ATTACHMENT B

PROPOSED CHANGES TO APPENDIX A, TECHNICAL SPECIFICATIONS
OF FACILITY OPERATING LICENSE DPR-19

DRESDEN II
Amendment No. 114

FIGURE 3.6.1.

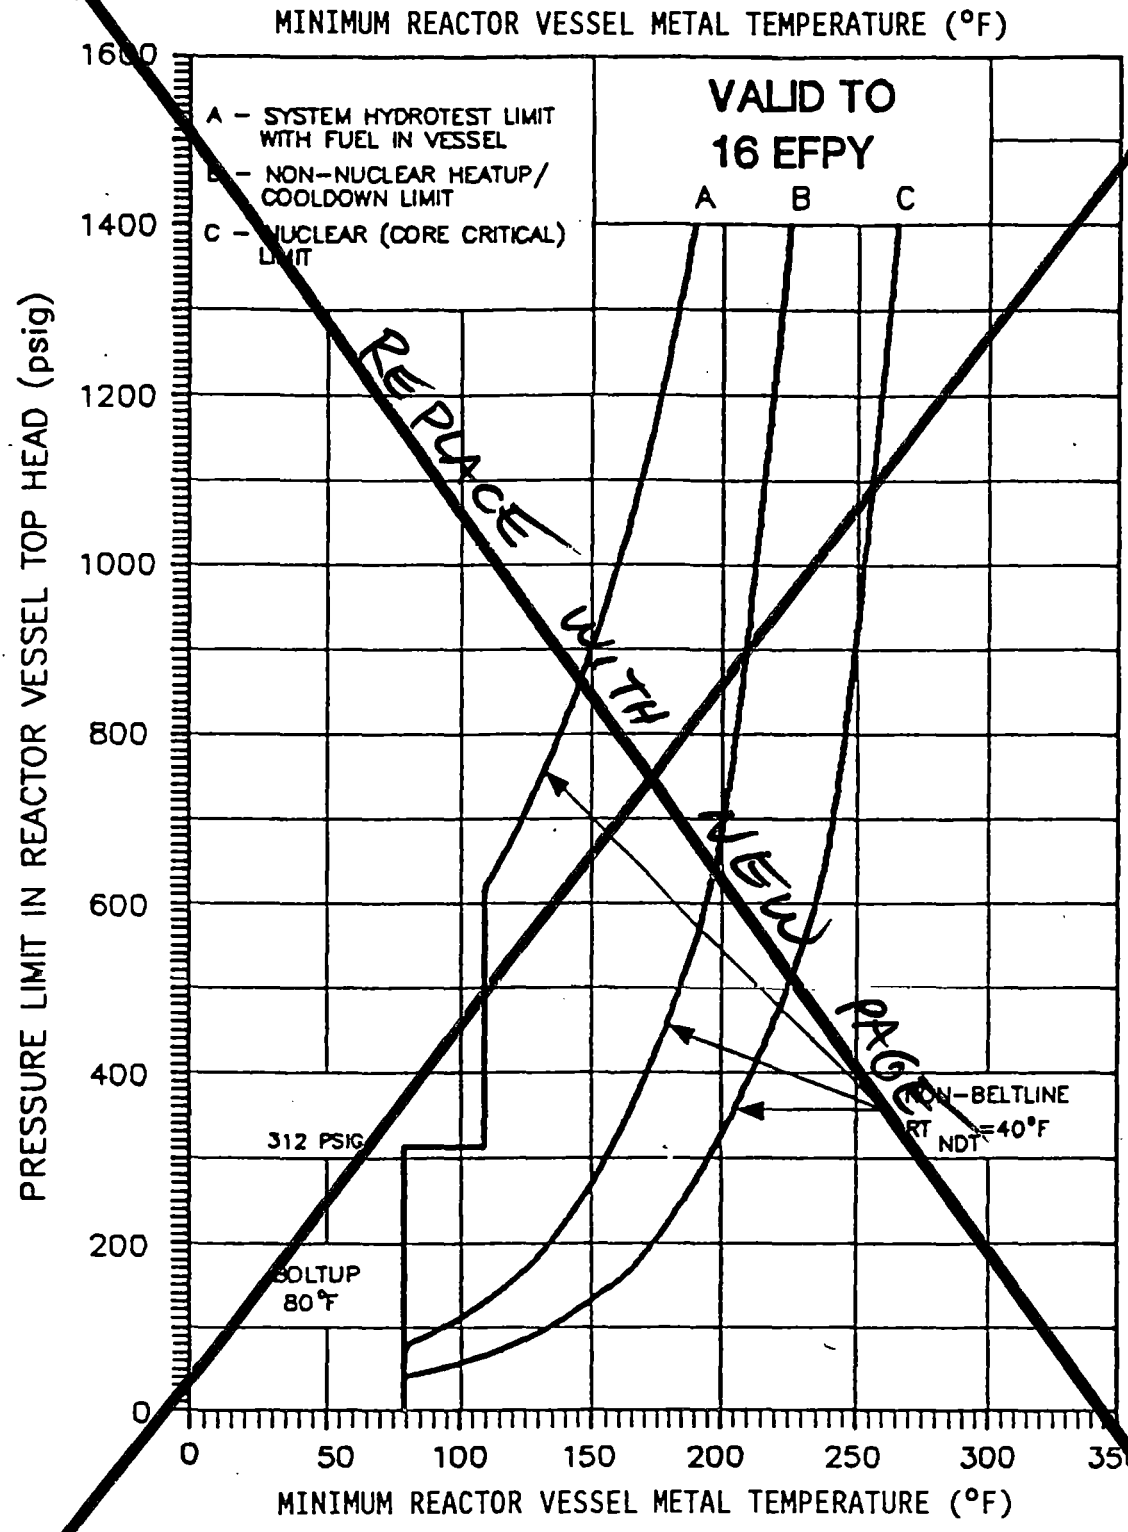
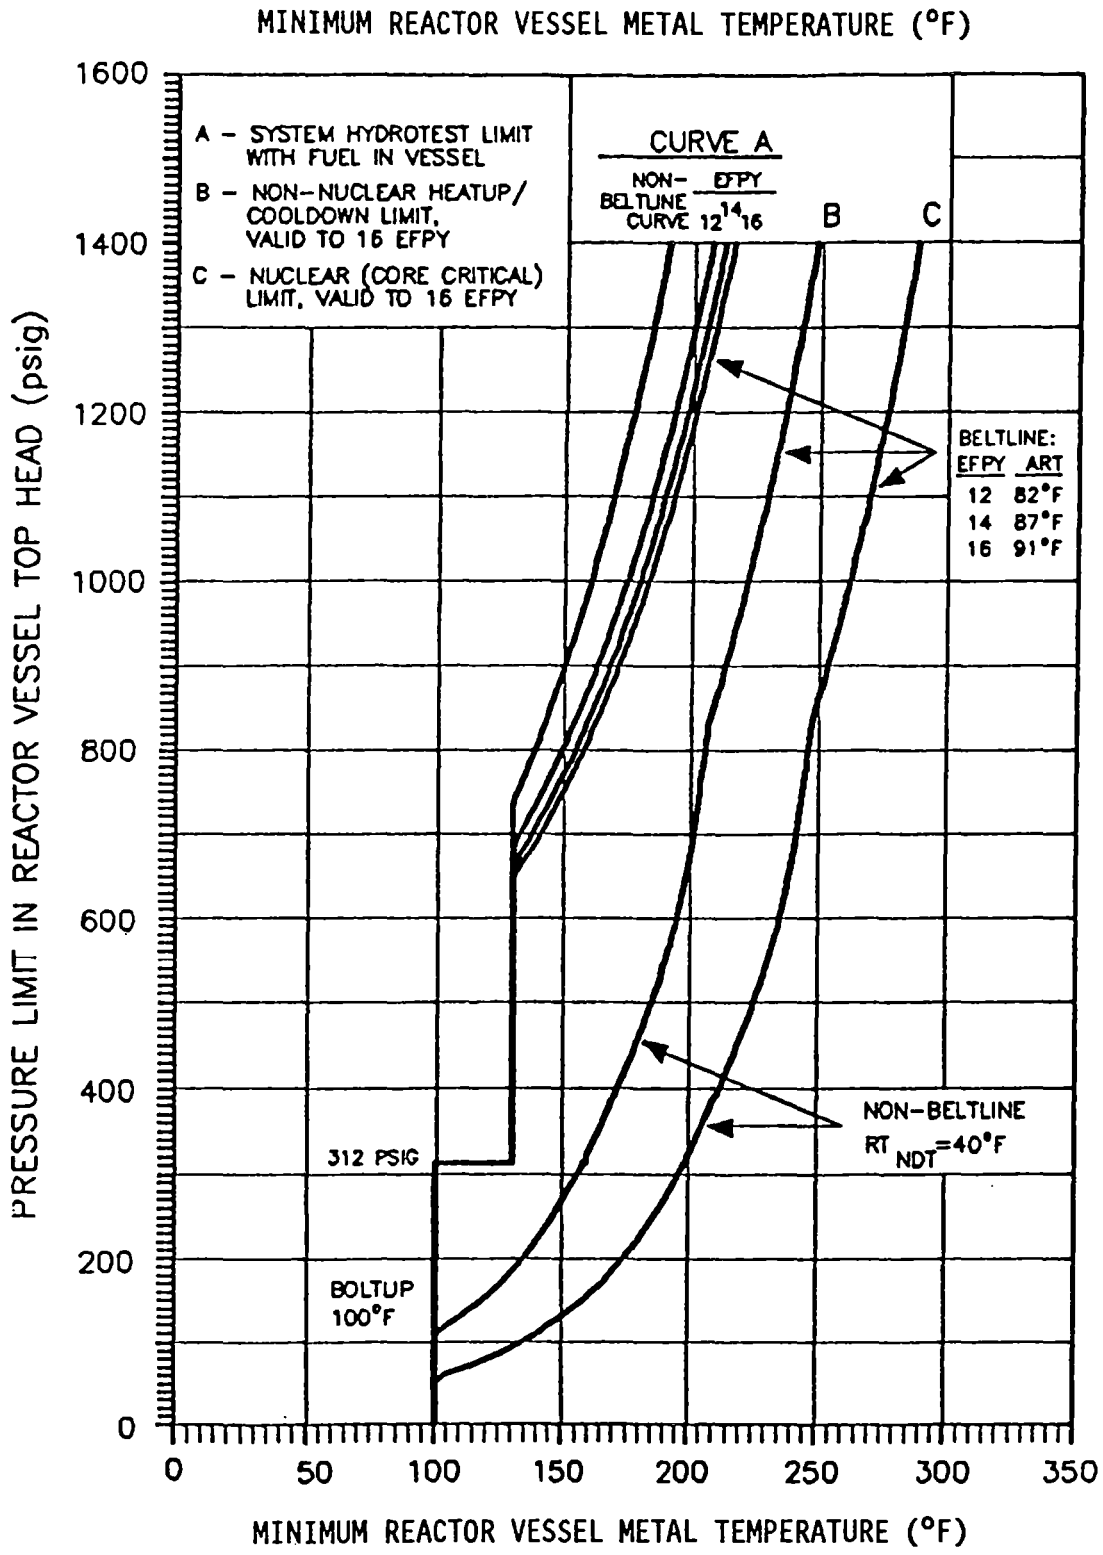
As indicated in Curve A of Figure 3.6-1 for system hydrotesting, the minimum metal temperature of the reactor vessel shell is 80°F for reactor pressures less than 312 psig. This 80°F minimum boltup temperature is based on an RT_{NDT} of 20°F for the top head plate (most limiting material) and a 60°F conservatism required by the original ASME Code of construction.

At reactor pressures greater than 312 psig, the minimum vessel metal temperature is established as 110°F. The 110°F minimum temperature is based on a closure flange region RT_{NDT} of 20°F and a 90°F conservatism required by 10 CFR 50 Appendix G for pressure in excess of 20% of the preservice hydrostatic test pressure (1563 psig).

At approximately 620 psig reactor pressure the effects of pressurization become more limiting than the boltup stresses at the closure flange region, as shown by the non-linear portion of Curve A intersecting the vertical 110°F line. The non-linear portion of the curve is dependent on the non-beltline region (which is actually more limiting than the beltline region through a vessel exposure of 22 effective full power years), and based on an RT_{NDT} of 40°F.

Curve B of Figure 3.6.1 applies during heatups with non-nuclear heat (e.g., recirculation pump heat) and during cooldowns when the reactor is not critical (e.g., following a scram). The curve provides the minimum reactor vessel metal temperatures based on the most limiting vessel stress (non-beltline stresses).

As indicated by the vertical 80°F line, the boltup stresses at the closure flange region are most limiting below approximately 80 psig. Above approximately 80 psig, pressurization and thermal stresses become more limiting than the boltup stresses, which is reflected by the non-linear portion of Curve B. The non-linear portion of the curve is dependent on non-beltline region (which is actually more limiting than the beltline region through a vessel exposure of 22 effective full power years), and based on an RT_{NDT} of 40°F.

Curve C, the core critical operation curve shown in Figure 3.6.1, is generated in accordance with 10 CFR 50 Appendix G which requires core critical pressure-temperature limits to be 40°F above any Curve A or B limits. Since Curve B is more limiting, Curve C is Curve B plus 40°F.

INSERT A

At approximately 650 psig the effects of pressurization are more limiting than the boltup stresses at the closure flange region, hence a family of non-linear curves intersect the 130 °F vertical line. Belt-line as well as non-beltline curves have been provided to allow separate monitoring of the two regions. Beltline curves as a function of vessel exposure for 12, 14, and 16 effective full power years (EFPY) are presented to allow the use of the appropriate curve up to 16 EFPY of operation.

INSERT B

As indicated by the vertical 100 °F line, the boltup stresses at the closure flange region are most limiting for reactor pressures below approximately 110 psig. For reactor pressures greater than approximately 110 psig, pressurization and thermal stresses become more limiting than the boltup stresses, which is reflected by the non-linear portion of Curve B. The non-linear portion of the curve is dependent on non-beltline and beltline regions, with the beltline region temperature limits having been adjusted to account for vessel irradiation (up to a vessel exposure of 16 EFPY). The non-beltline region is limiting between approximately 110 psig and 830 psig. Above approximately 830 psig, the beltline region becomes limiting.
